ADDENDUM NO. 4

REPLACEMENT OF THAMES STREET WALL AT ELECTRIC BOAT
GROTON, CT

MMI #2536-13
December 9, 2019

ADDENDUM NO. 3

KP	NP	KP
DESIGNED	DRAWN	CHECKED
SCALE: 1"=10'		
DATE: NOVEMBER 22, 2019		
PROJECT NO.: 2536-13		
DRAWING NO.: STR-01

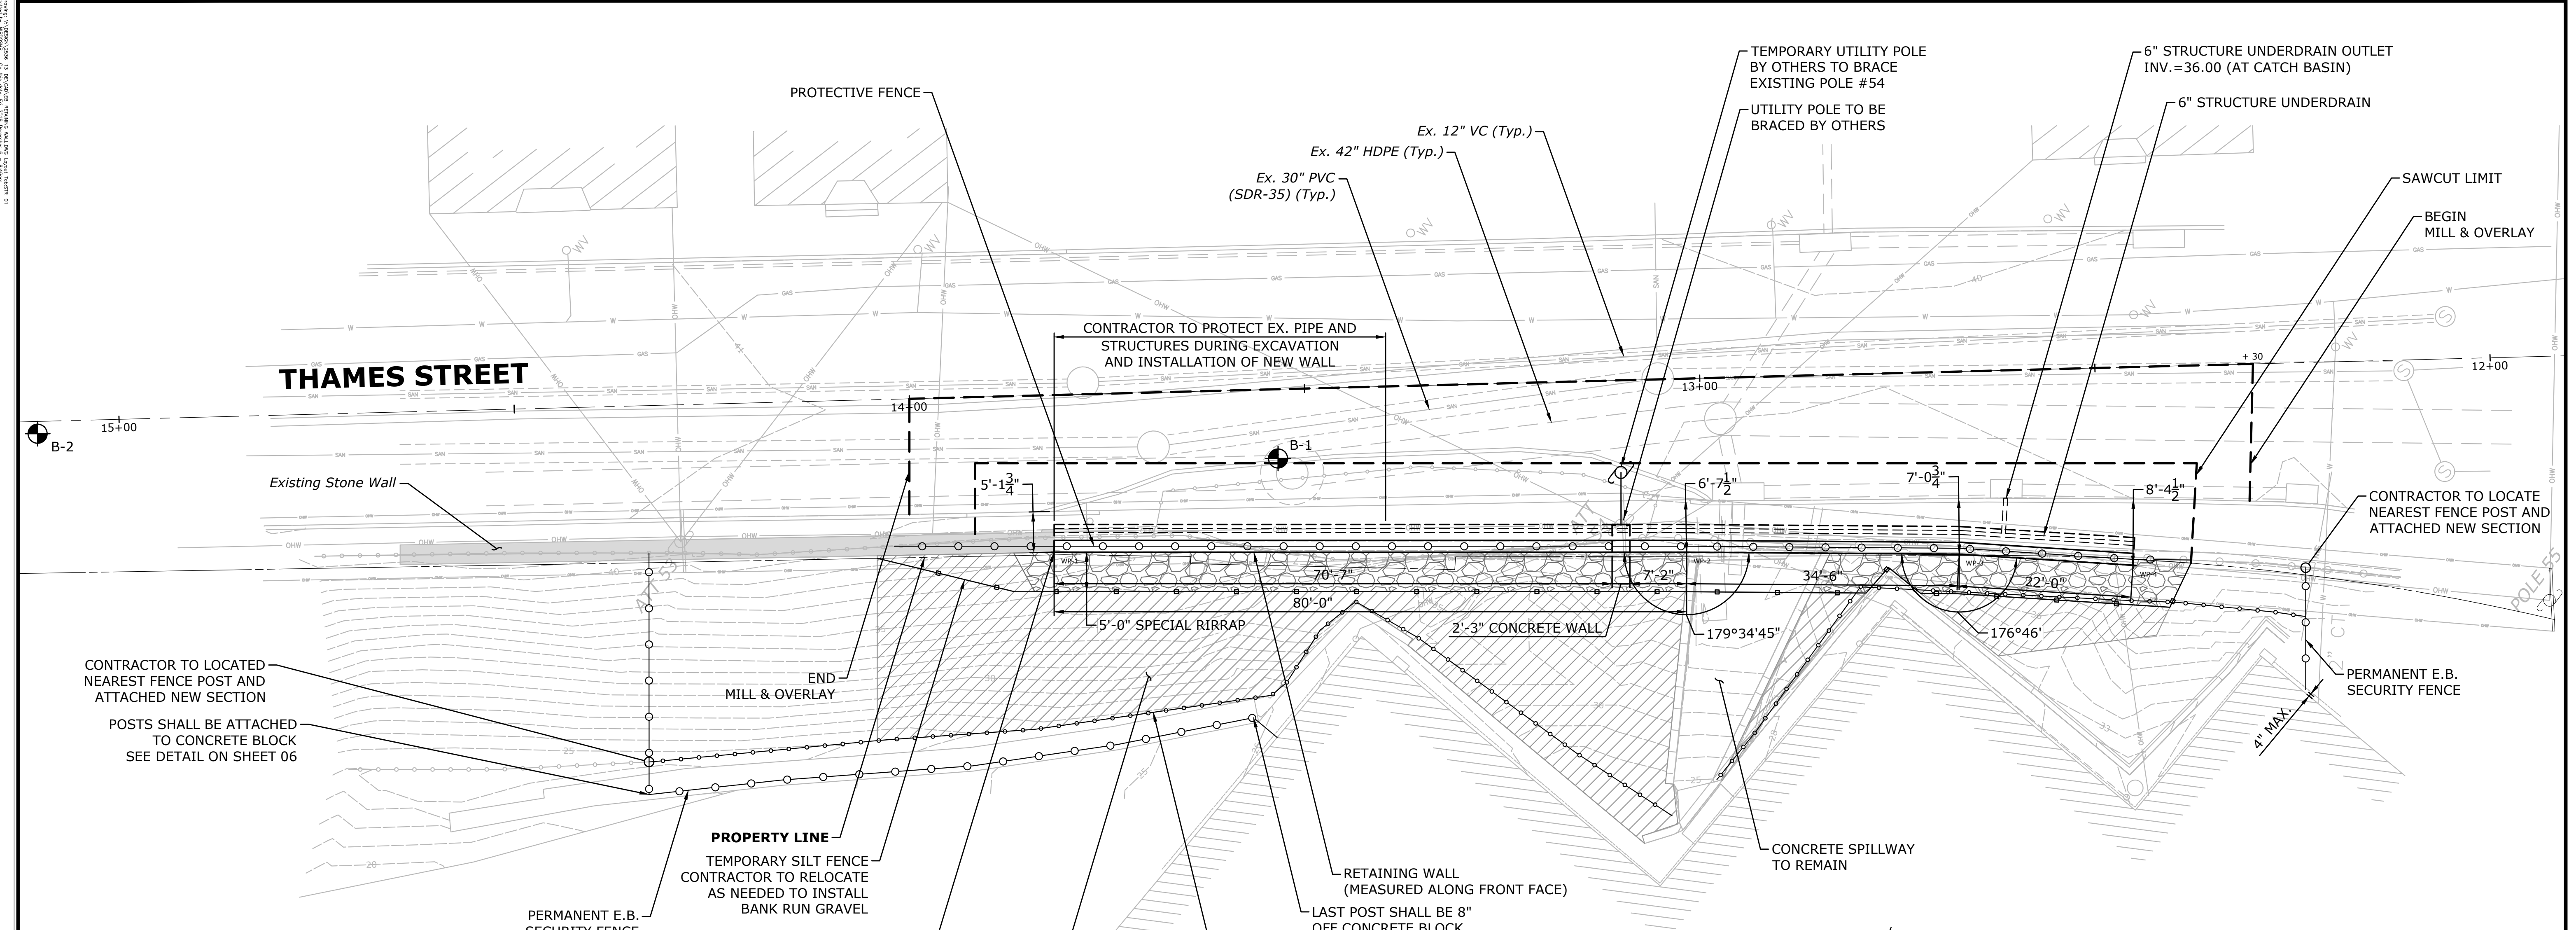
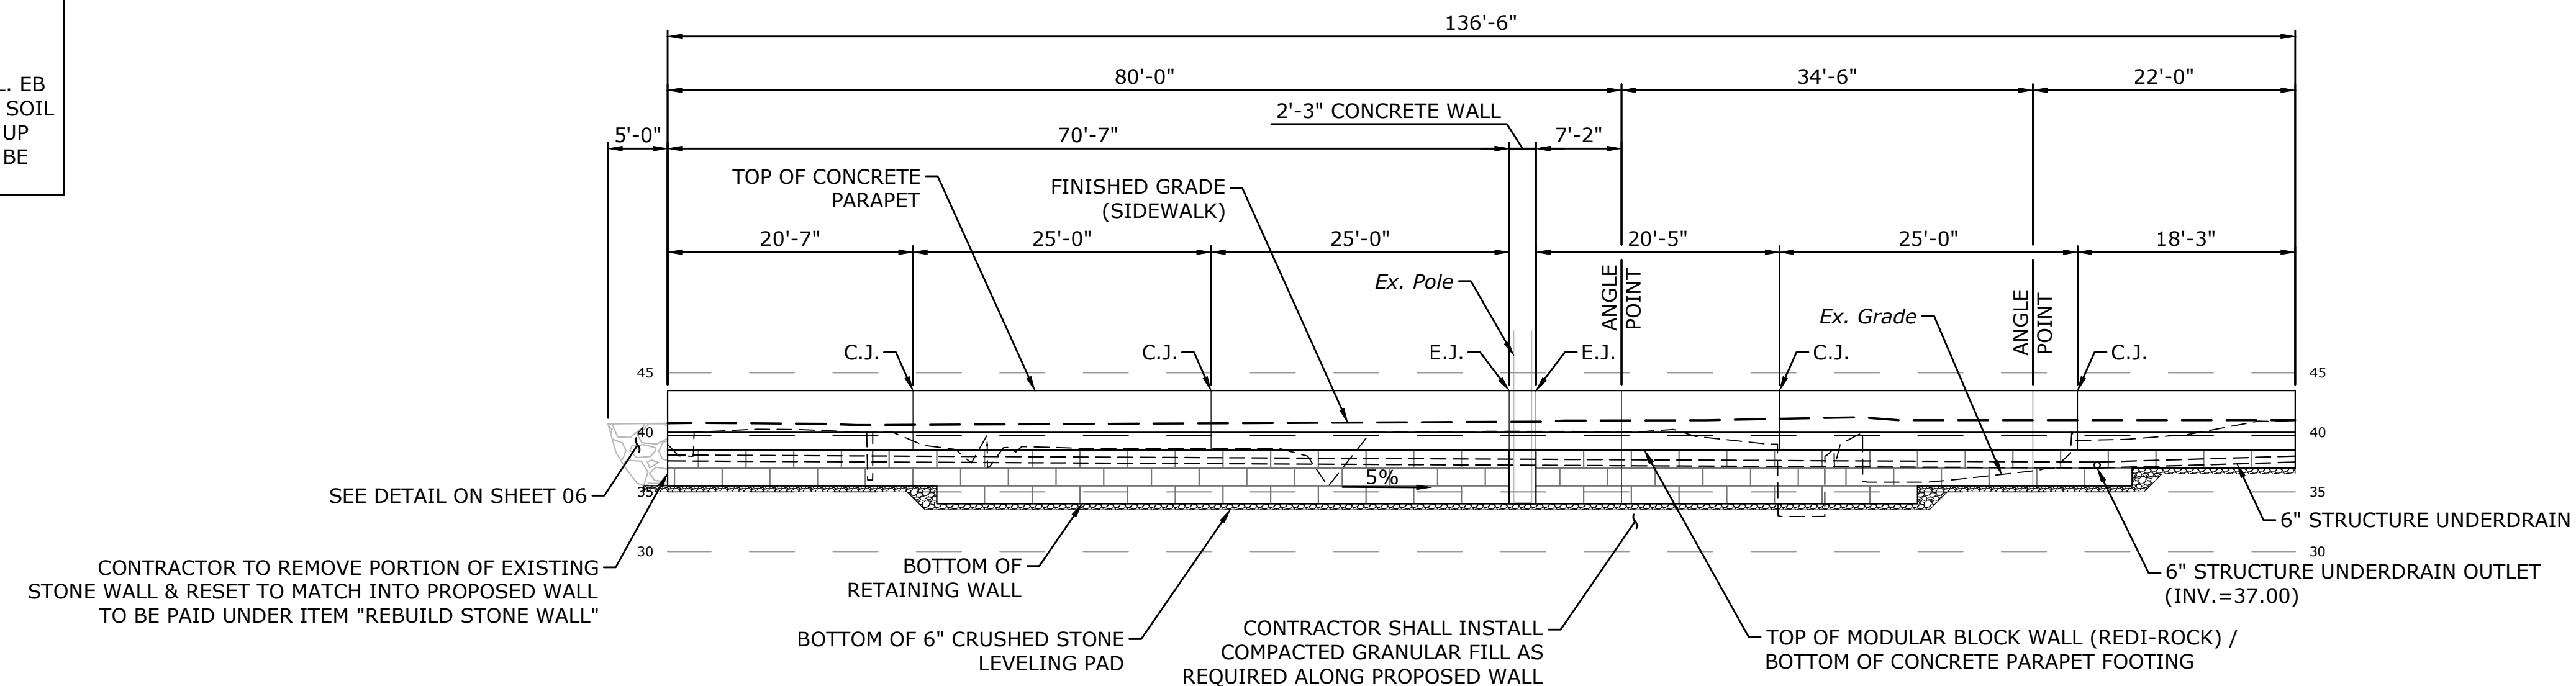
Q2: What are the pay limits for Item #214000 "Compacted Gravel Fill"?

Q5: What are the pay limits for Item #728016 "3 Inch Crushed Stone"?

R2: The item is for contractor to bring up grade under the footings of embankment wall necessary to maintain the bottom of wall shown on the elevation view on sheet STR-01.

R5: See sheet STR-01 on bottom left hand corner under Legend the hatched area is the limits for 3" Crushed Stone.

MODULAR BLOCK UN-REINFORCED WALL

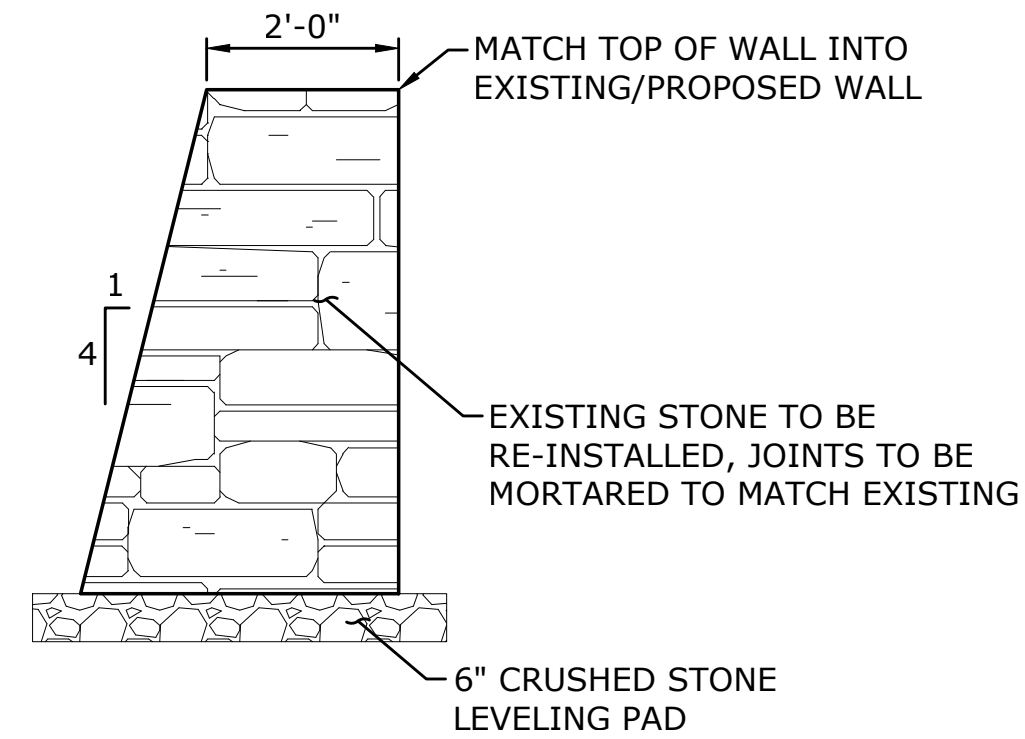
Q4: What are the pay limits for Item #728014 "3/4 Inch Crushed Stone"?

R4: See "Modular Block Un-Reinforced Wall Section" on sheet STR-02, the ¾" crushed stone shall be the crushed stone levelling pad and drainage aggregate behind the blocks.

REMOVE & RESET EXISTING STONE WALL

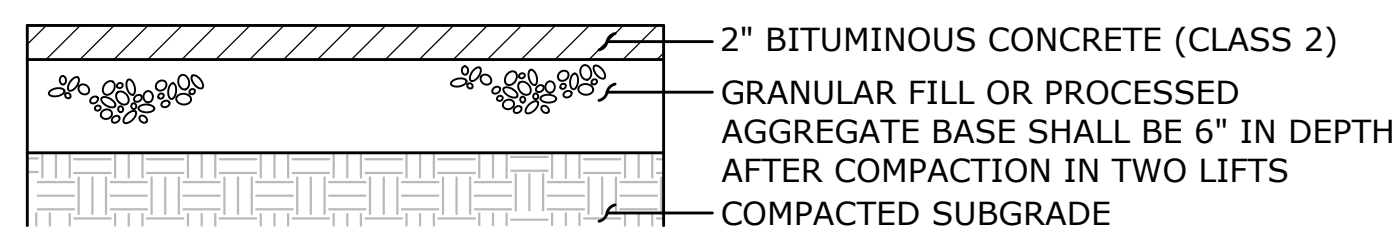
Q16: Please provide the special provision for Item #905018A – Rebuild Stone Wall.

R16: A detail has been provided on sheet STR-02. The “A” has been removed from the item number.
